**ADDENDUM  
NO. 2**

**November 4, 2021**

**Portage Township School - Bid Package #2  
PHS Learning Lab, Elementary Schools Media Centers, and Office Renovation  
Portage IN, 46368**

## ADDENDUM NO. 2

ADDENDUM DRAWING NO. MEDIA 0.0A

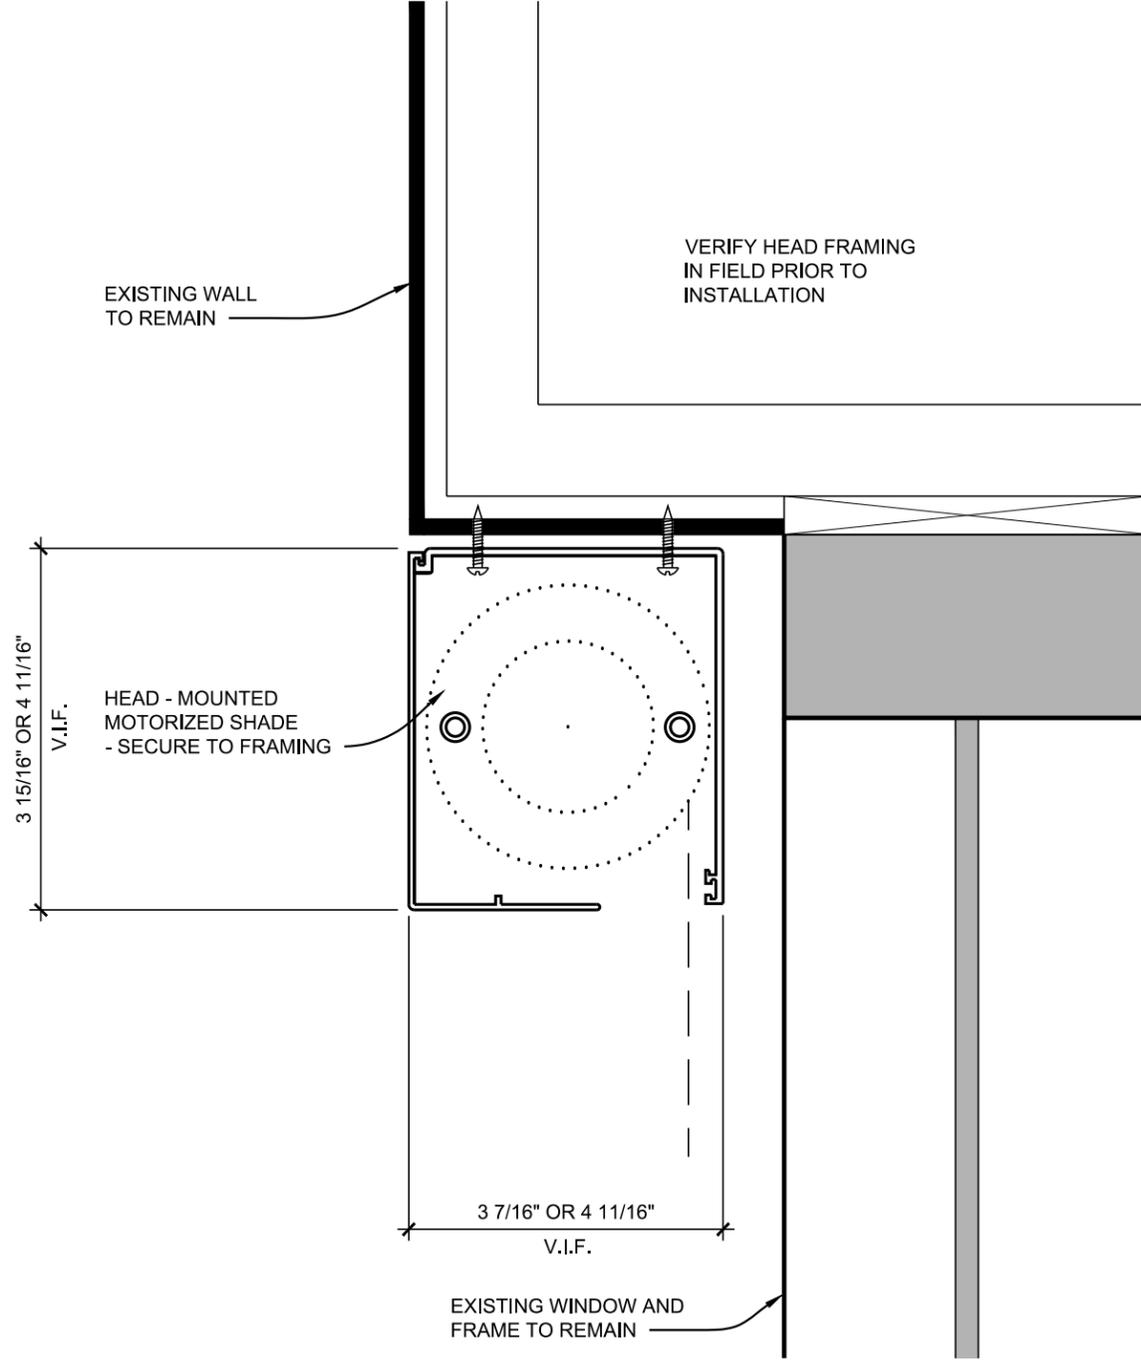
16. **DRAWINGS**; Sheet No. MEDIA 0.0:
  - a. MOTORIZED WINDOW BLINDS DETAIL 1/0.0: Replace this detail with Addendum Drawing No. MEDIA 0.0A, dated 11/1/21.

ADDENDUM DRAWING NO. MEDIA 0.0B	ADDENDUM NO. 2		
<p><b>ALLIANCE</b> ARCHITECTS 929 Lincolnway East, Suite 200   South Bend, Indiana 46601</p>	DATE 11/1/21	DRAWING SHT. 0.0	<p>PORTAGE TOWNSHIP SCHOOLS LEARNING LAB, MEDIA CENTERS, OFFICE AND OFFICE PROJECT PORTAGE, INDIANA</p>

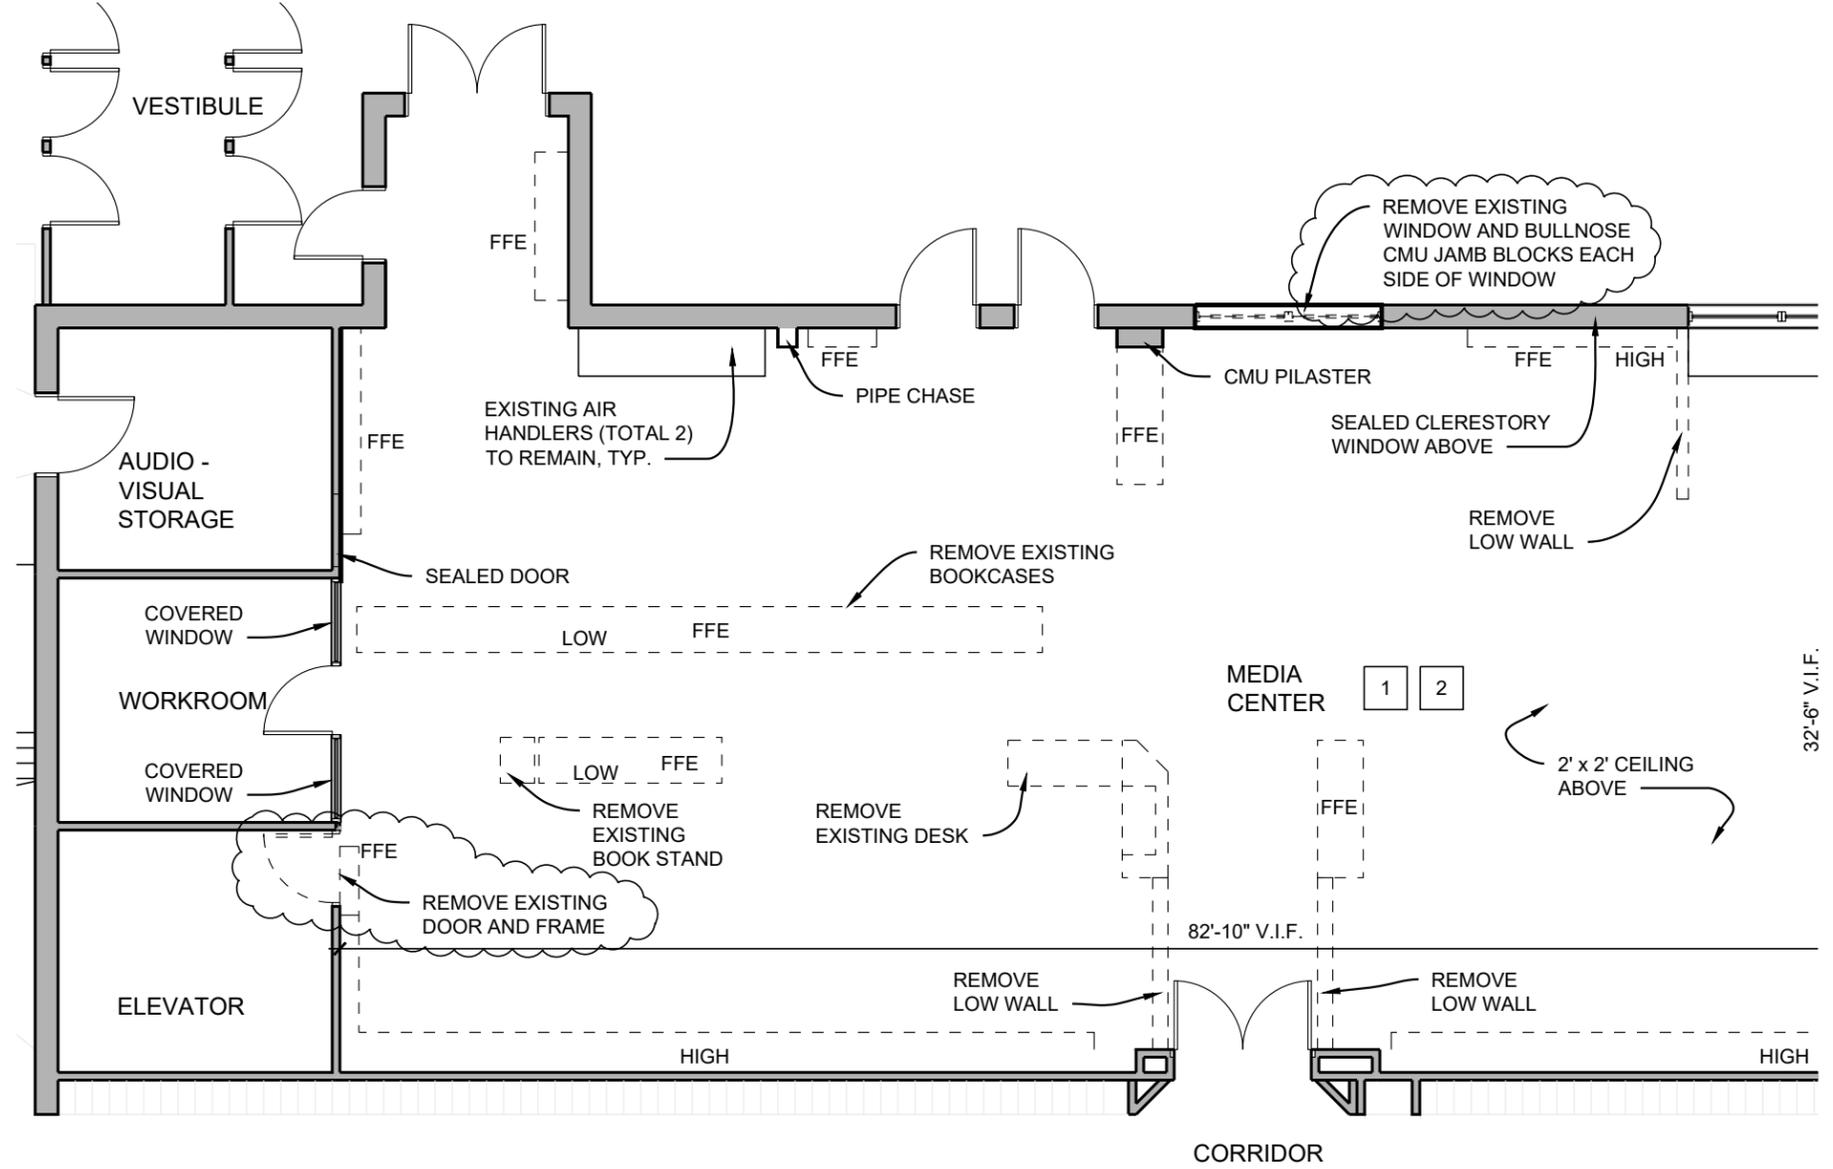
- b. MOTORIZED WINDOW BLINDS DETAIL 2/0.0: Replace this detail with Addendum Drawing No. MEDIA 0.0B, dated 11/1/21.
17. **DRAWINGS**; Sheet No. MEDIA 1.3; ELECTRICAL PLAN NOTES; NOTE 6: By way of clarification, Panel 2 is located approximately 30' from the Media Center main door, across the corridor, inside Ventilation Room 19.

ADDENDUM DRAWING NO. MEDIA 4.0A

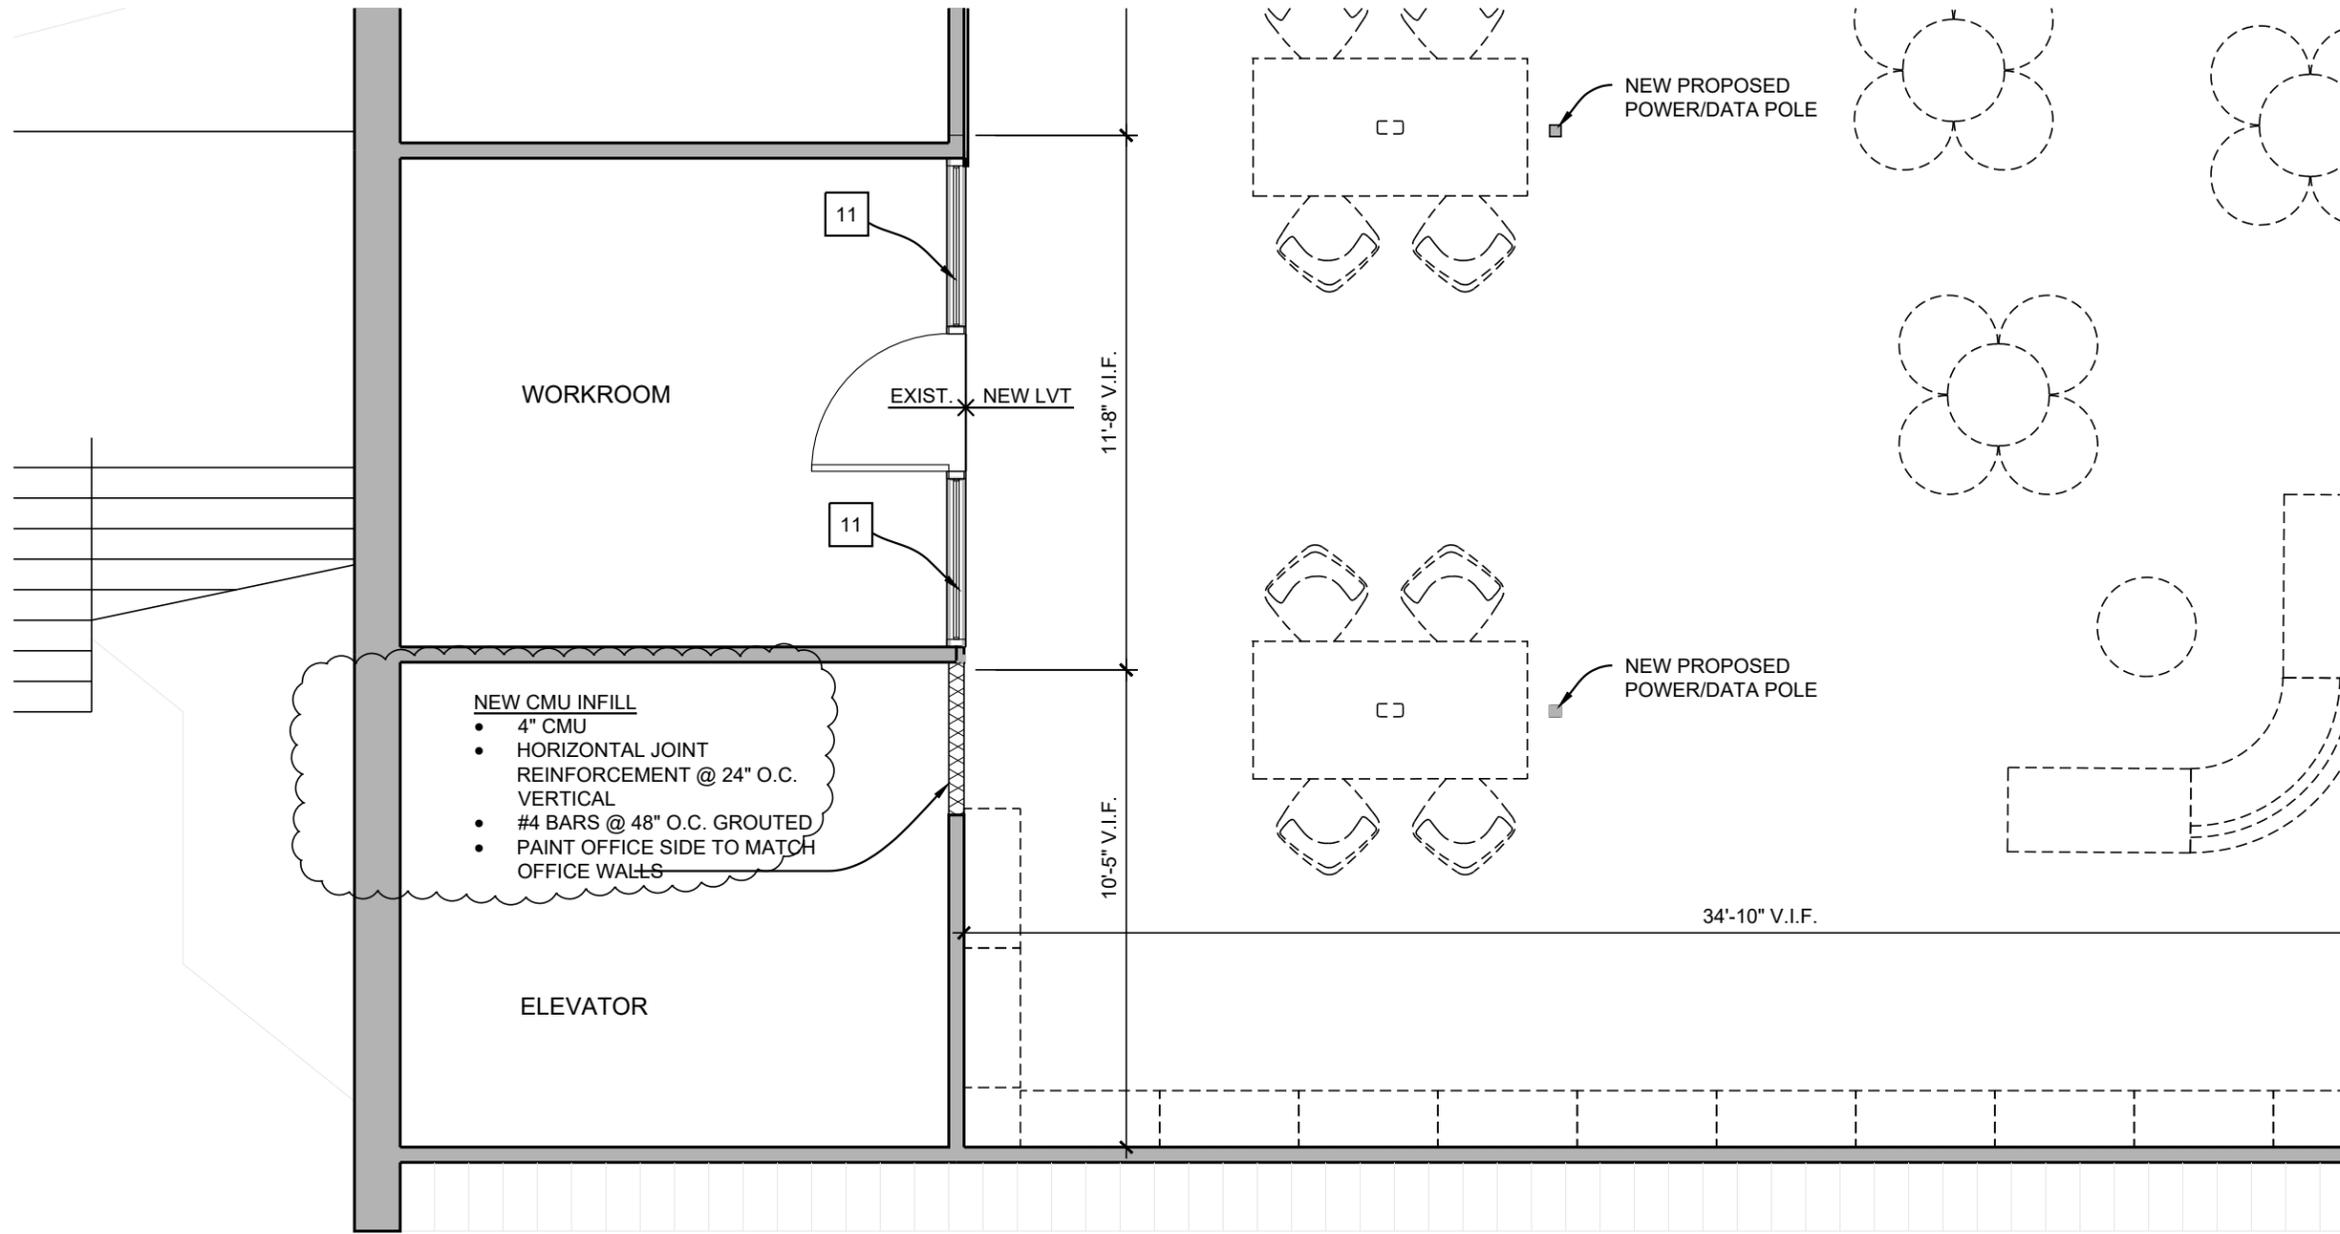
20. **DRAWINGS**; Sheet No. MEDIA 4.0:
  - a. DEMOLITION PLAN: Revise the Demolition Plan as shown on Addendum Drawing No. MEDIA 4.0A, dated 11/1/21.
  - b. FLOOR PLAN:

ADDENDUM DRAWING NO. MEDIA 4.0B

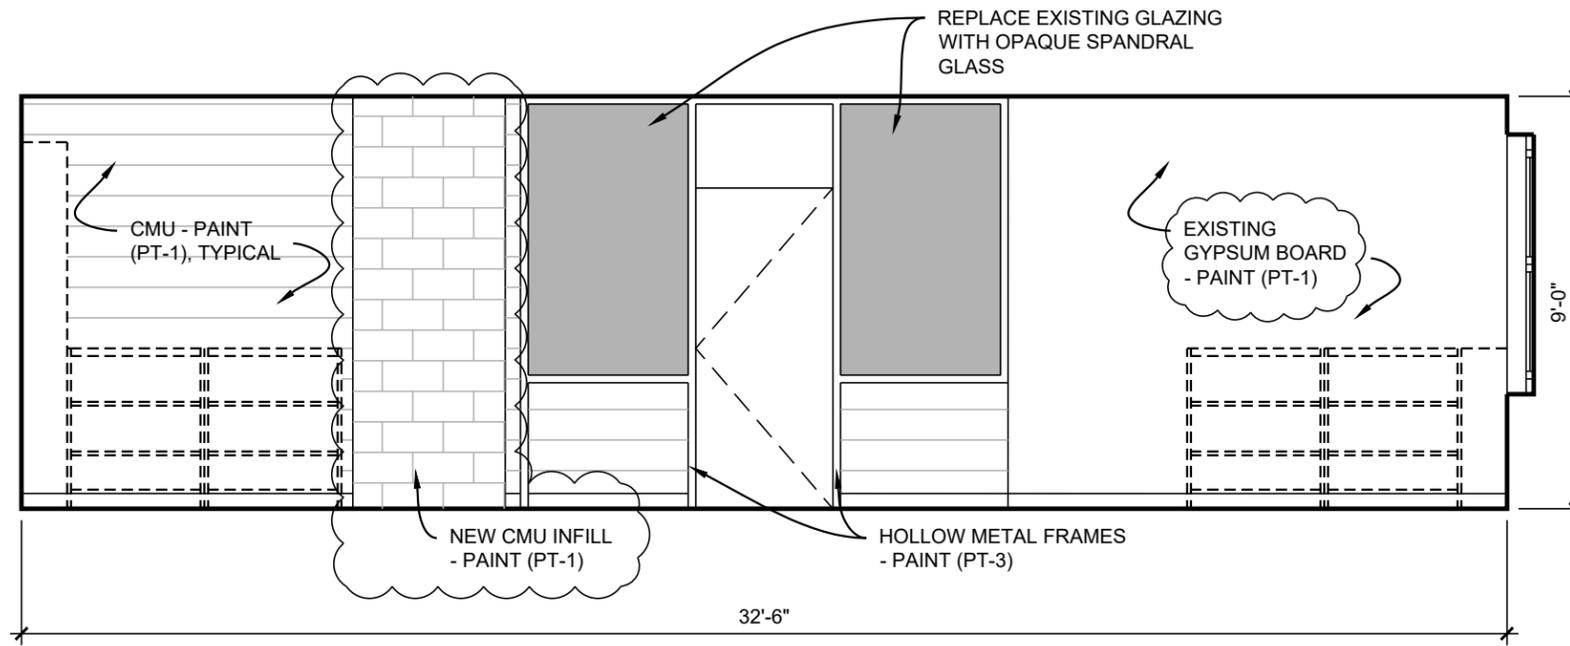
- 1) Revise the note at the window infill on the north wall to reference 12" CMU. The remaining portions of the note shall remain as shown.

- 2) Revise the Floor Plan as shown on Addendum Drawing No. MEDIA 4.0B, dated 11/1/21.
21. **DRAWINGS**; Sheet No. MEDIA 4.1; WEST ELEVATION 4/4.1: Replace this elevation with Addendum Drawing No. MEDIA 4.1A, dated 11/1/21.
